**Response to the “Notice of Disapproval for the Work Plan to Investigate
the Source of Polychlorinated Biphenyls at LA-SMA-2”
Dated March 4, 2008**

INTRODUCTION

Attachment 2
Stormwater Monitoring Location
LA-SMA-2

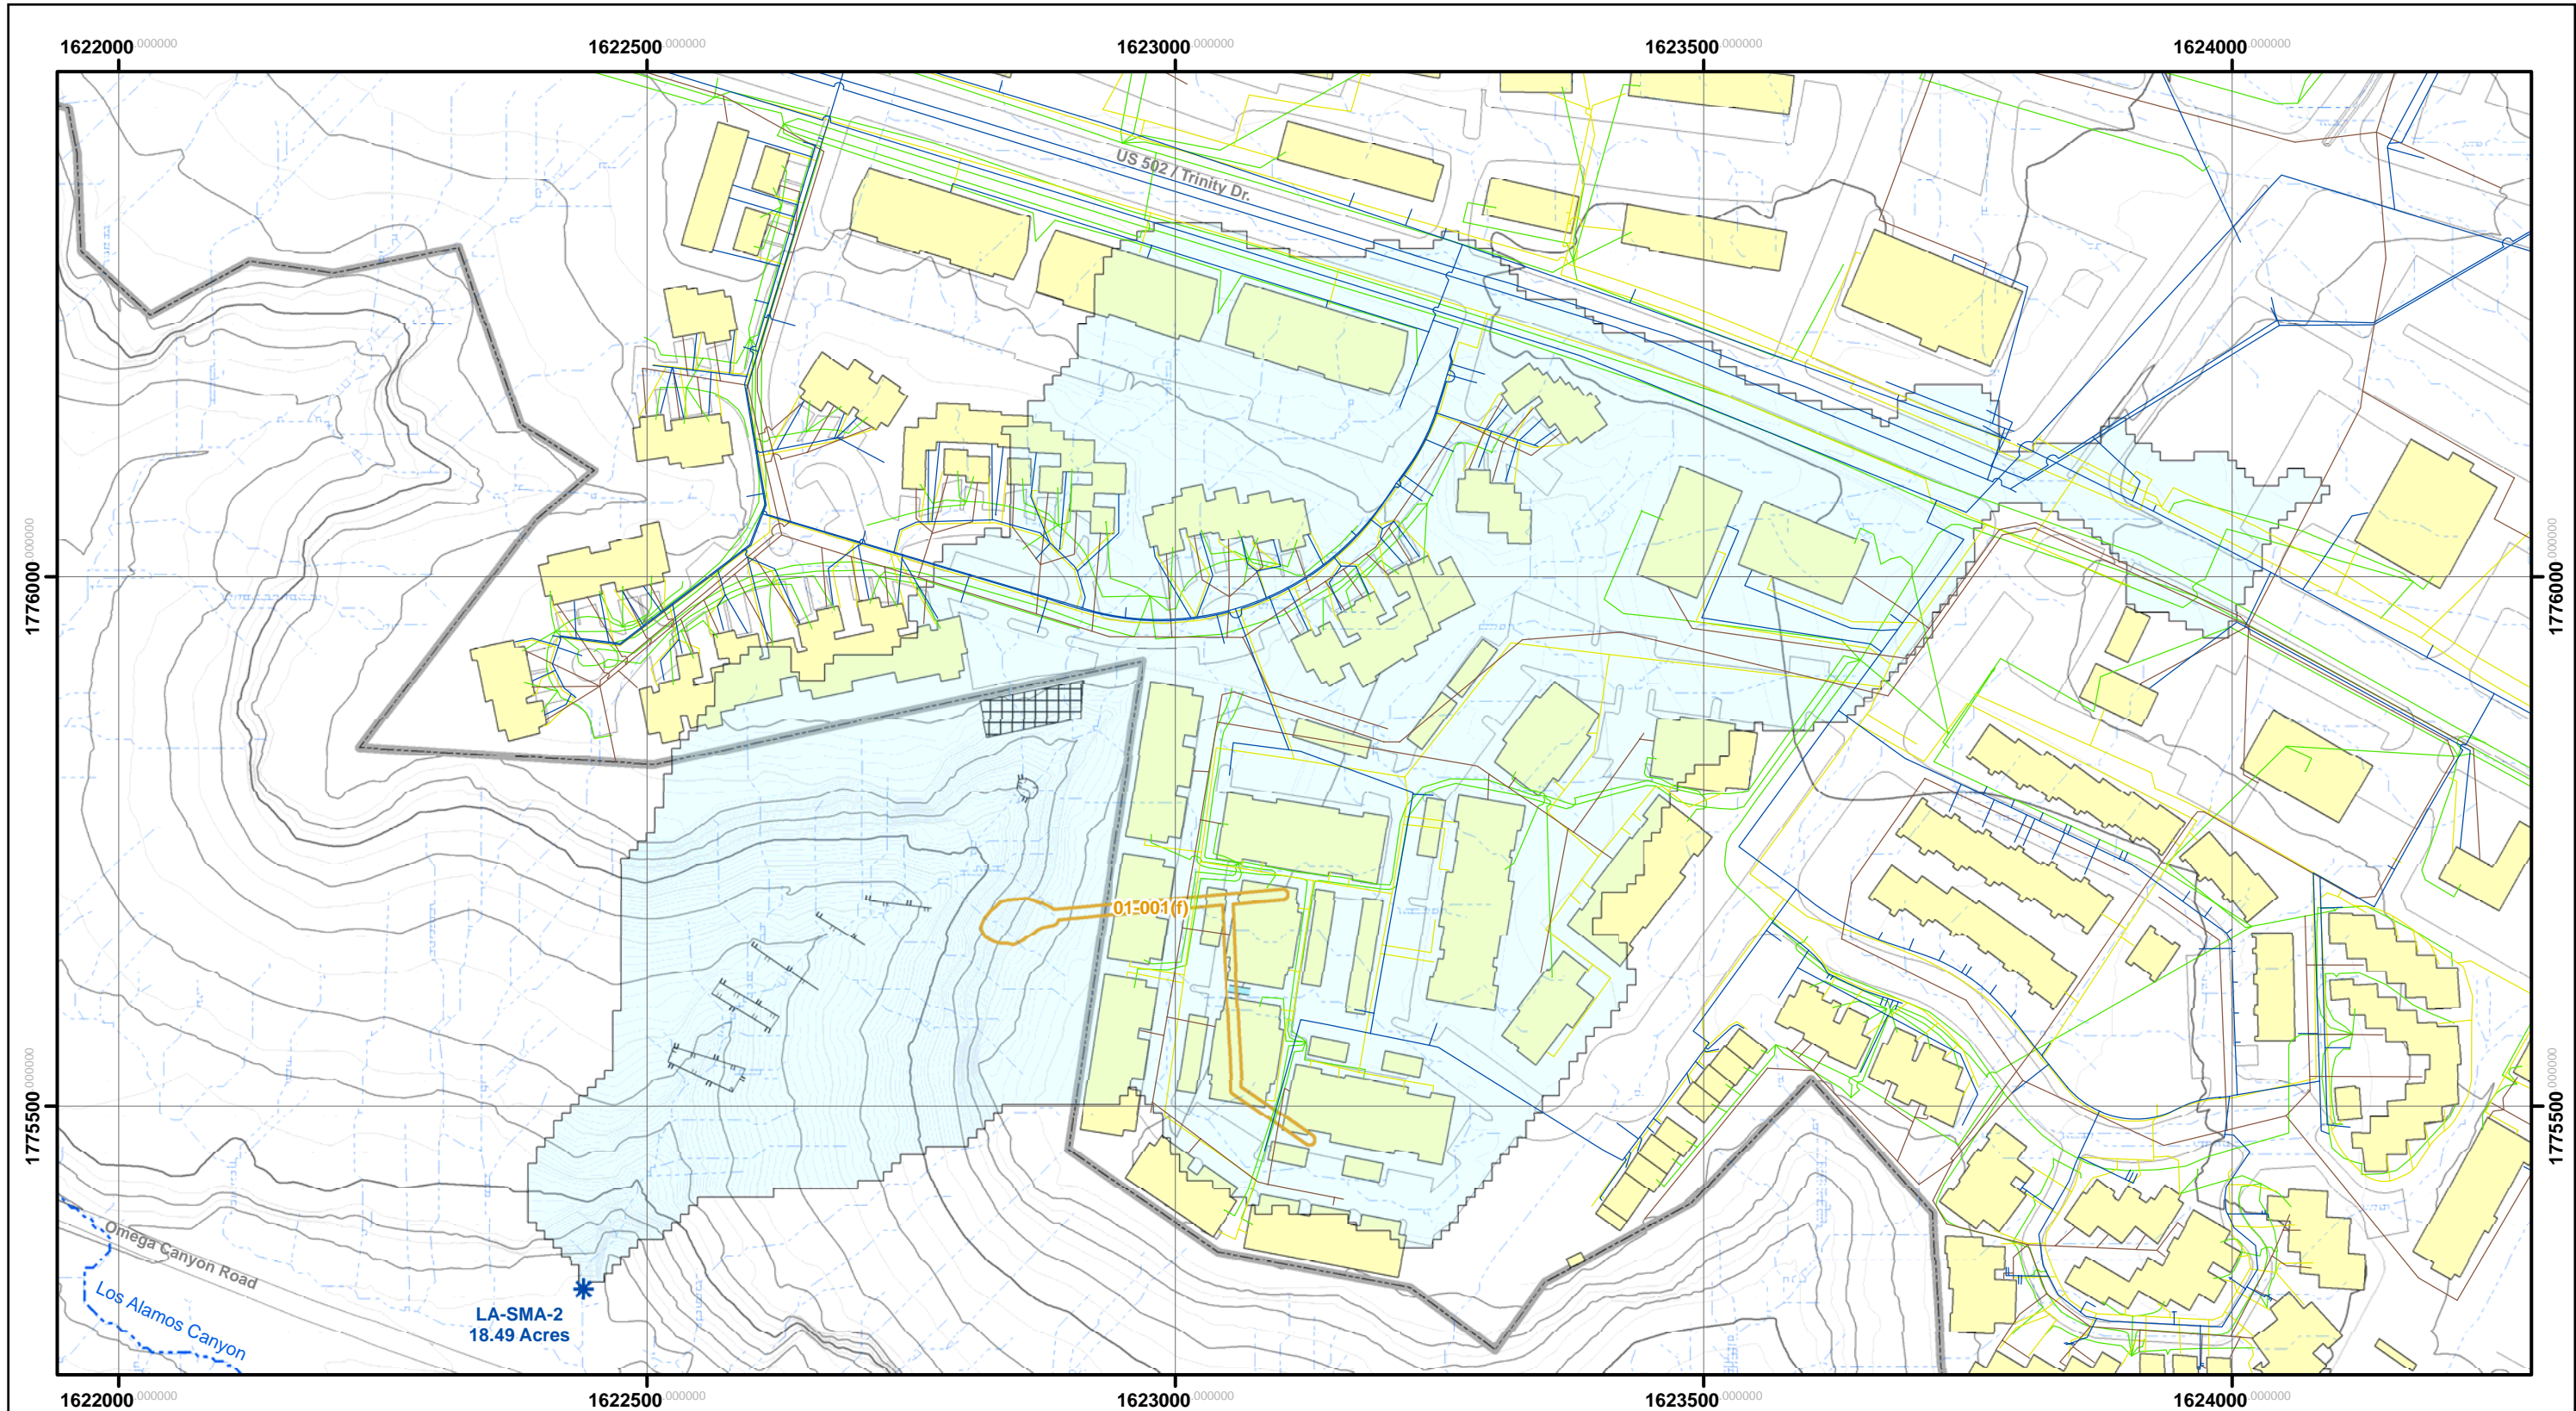
2. *If storm water monitoring is being conducted under a different program, the Permittees may provide the monitoring schedule, procedures, analyte list and identify any constituents that have been detected thus far in storm water samples, but details of the monitoring program must nonetheless be provided in the response. The samples proposed for collection in addition to those in the Investigation Work Plan for Upper Los Alamos Canyon Aggregate Area are not depicted on the figure provided. The Permittees must revise the figure to include all proposed sampling locations relative to LA-(storm water management area (SMA)-2. The revised figure must also clearly indicate the location of LA-SMA-2 and the location of the storm water monitoring location(s). In addition, a figure must be provided that illustrates the location of all under ground utilities, active outfalls, stormwater outfalls and former outfalls.*

Attachment 2 is a figure of LA-SMA-2 that provides the details requested in NMED's Comment 2, including the location of the stormwater-runoff sampler, buried utilities, the drainage network ("stormwater outfall"), and the former outfall [e.g., the location of the septic tank, Solid Waste Management Unit (SWMU) 01-001(f), and its outfall].
